Plainfield High School – FOH Rigging Recommendation

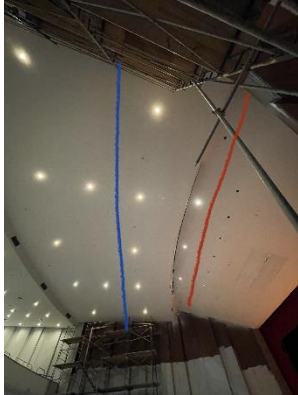
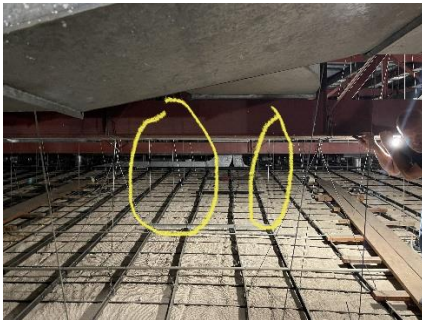
Red and blue lines are the locations of where the I-Beams are in the ceiling. The Red line is too close to the stage and not an optimal lighting position. The blue is where we need to go. From that beam it is 39' - 3" to the proscenium wall above the ceiling. From center stage to that location it is 58'. From the proscenium wall onstage 46'.

For the preferred new position we identified from the I-Beam to the ceiling, cable supports. These supports would have to be removed from the beam and transferred to another location or removed entirely if it is deemed safe. This is a request from North East Stage.

We also noticed the walking planks throughout to the preferred I-Beam making access to it much easier on both sides of the ceiling.
